-TOLERANCES- UNLESS OTHERWISE SPECIFIED	 东莞市德索精密工业有限公司 Dongguan Dosin Precision Industry Co., Ltd					
	PART DESCRIPTION: H-MTD FEMALE TO USB TYPE A 3.0 MALE CABLE					
UNLESS OTHERWISE SPECIFIED TOLERANCES FOR MILLIMETERS ARE: 0.5 - 8mm ± 0.20mm 8 - 30mm ± 0.25mm 30 - 120mm ± 0.30mm	Appr: JIM. KING	P/N: DOSIN-811-8401				
	Check:	Date	Scale	Unit	Type	Page
	Draw: Gavin	2026.04.15	Free	MM	Z	1/1

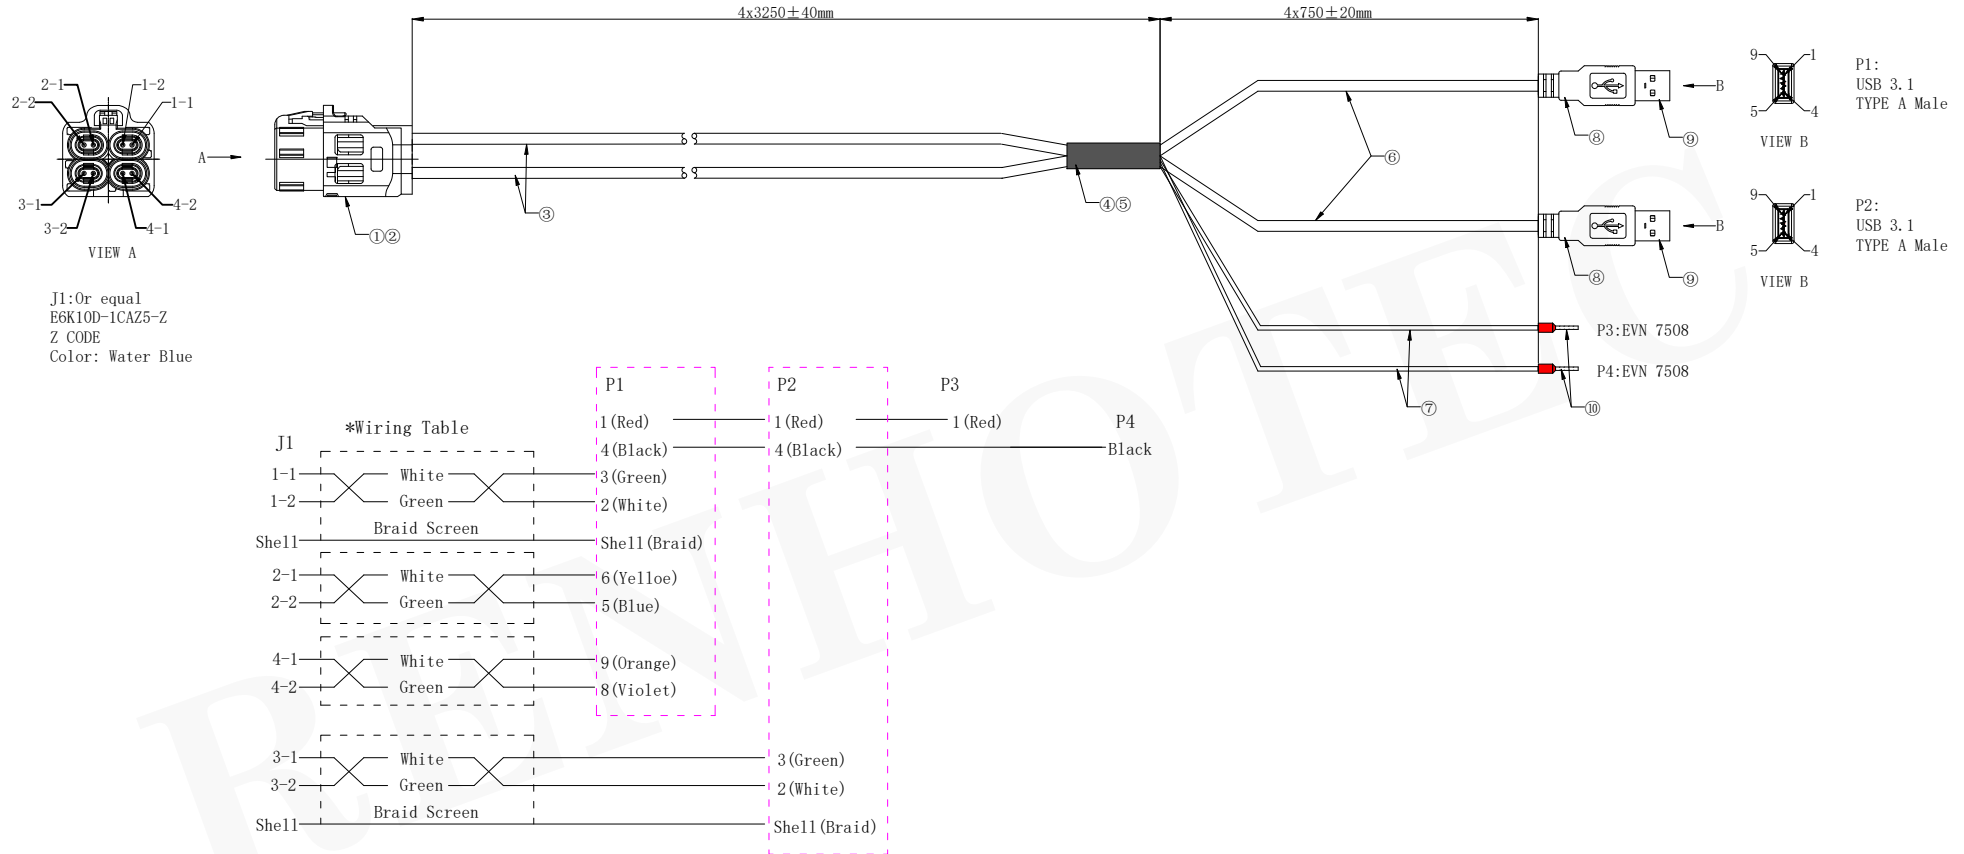
REV	DESCRIPTION	DWN	DATE	APPROVEN
A	First issue	Gavin	2026/04/14	JIM. KING
B	Change the cable length to 3250mm and 750mm USB 3.0 Male connector changed to USB 3.1 Male	Gavin	2026/04/15	JIM. KING
